March 7, 2014  
Subject: **South Bristol**  
Federal Project No: BH-1675(000)X  
State WIN: 016750.00  
**Amendment No. 2**

Make the following changes to the Bid Documents:

**HOLDING TANK PLAN**

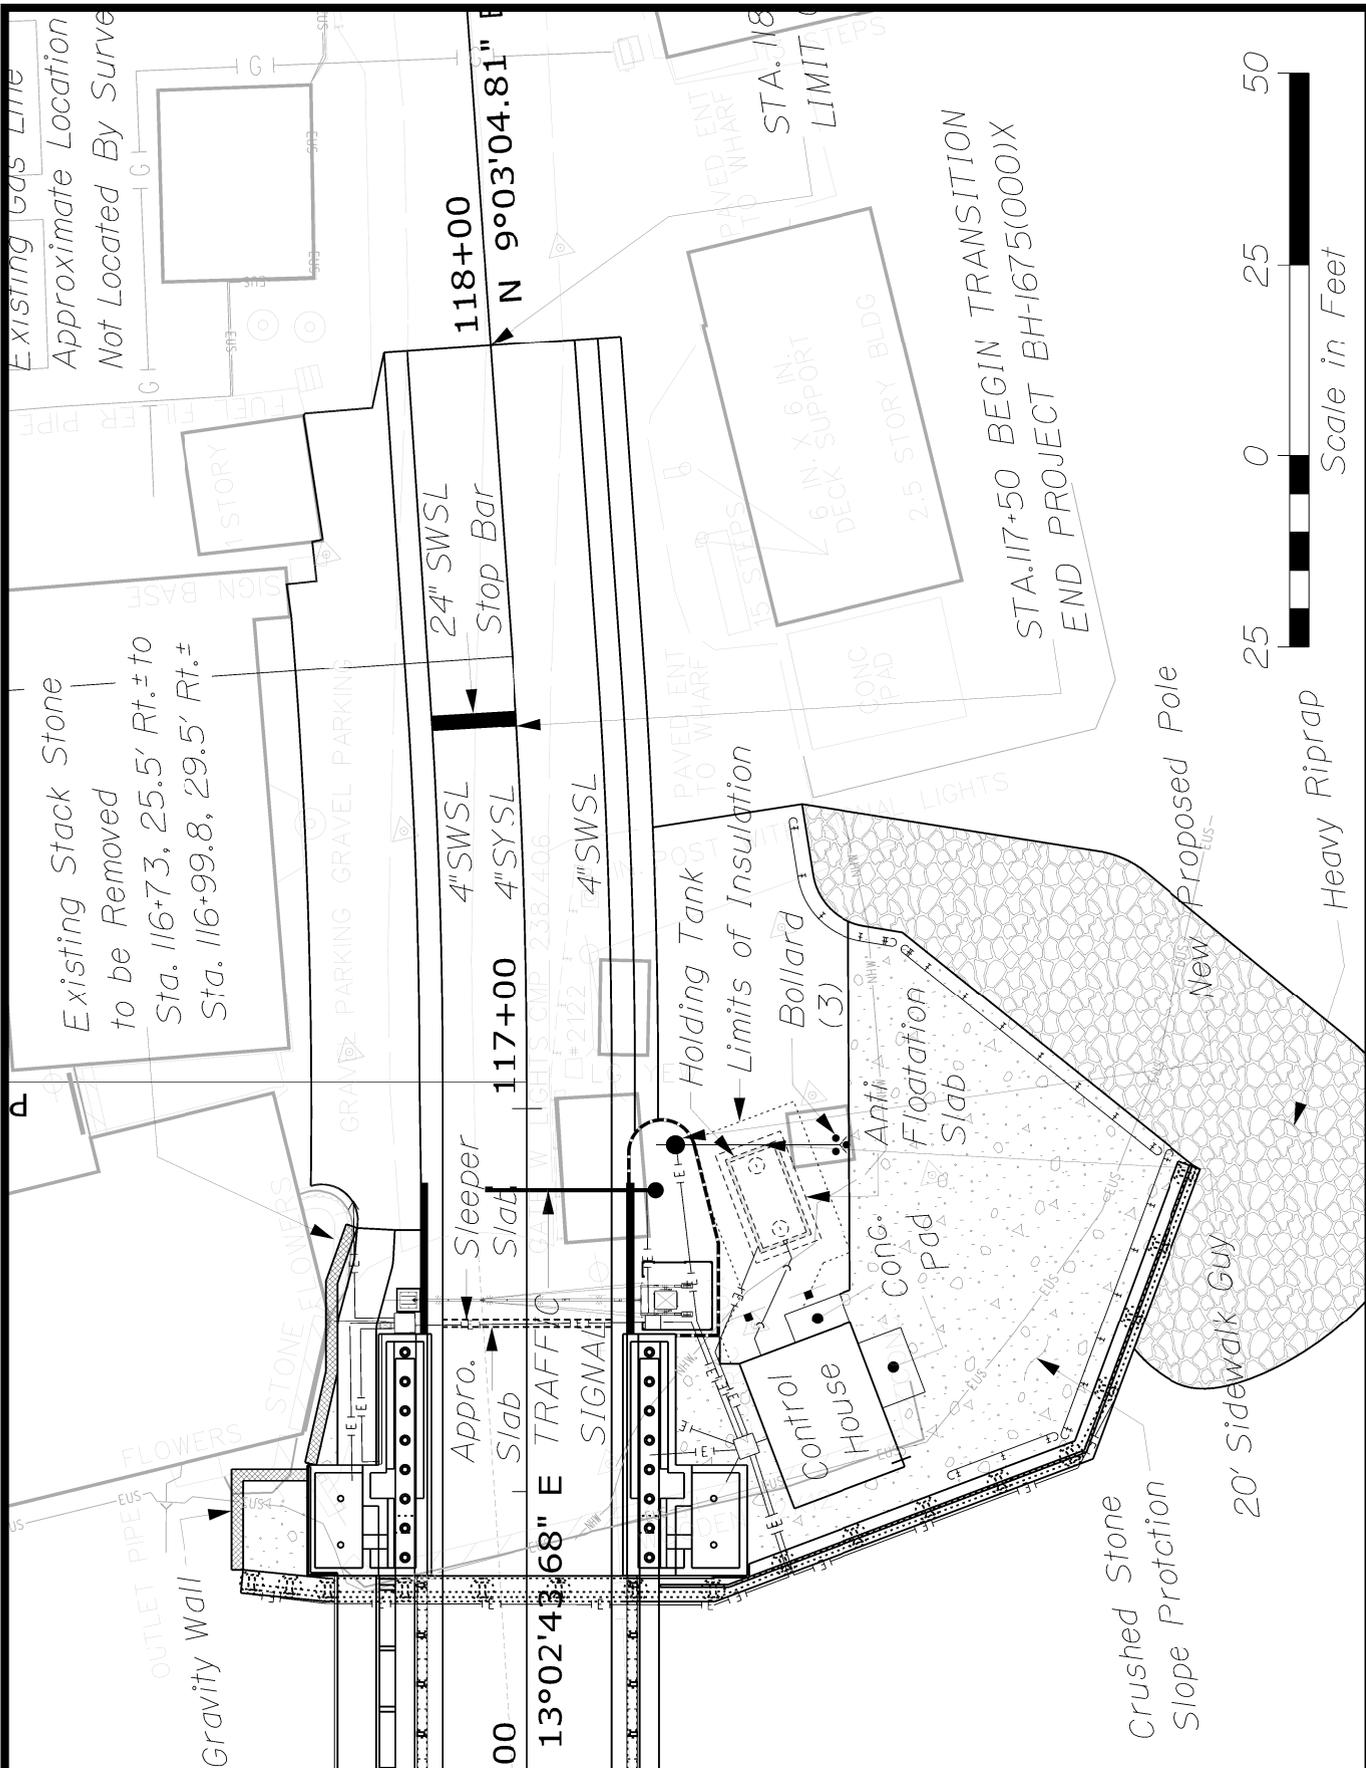
In the Bid Book (pages 106 and 107) **REMOVE** "SPECIAL PROVISION, SECTION 203, HOLDING TANK" 2 pages dated January 3, 2014 and **REPLACE** with the attached new "SPECIAL PROVISION, SECTION 203, HOLDING TANK" 2 pages dated February 27, 2014 **AND** 4 attached details labeled "ATTACHMENTS A, B, C and D" for a total of 6 pages..

Description: This work shall consist of excavation, furnishing materials, installing, backfilling and testing a 2,000 gallon holding tank. The holding tank shall include a 2,000 gallon precast concrete holding tank with an overflow alarm system, anti-flotation cast in place concrete slab including reinforcing steel, cast in place concrete attachment ring, precast riser pieces and 24" diameter cast iron manhole. This work also includes the piping, conduit and wiring required from the operator building to the holding tank.

Materials: The holding tank shall be constructed of reinforced precast concrete with a minimum 28 day compressive strength of 4,000 psi, concrete partitioned chambers, concrete lid with lift rings, vent, inlet inspection hole, and inlet turned down 12 inches below effluent level. The holding tank, risers and covers shall be designed for H2O loading.
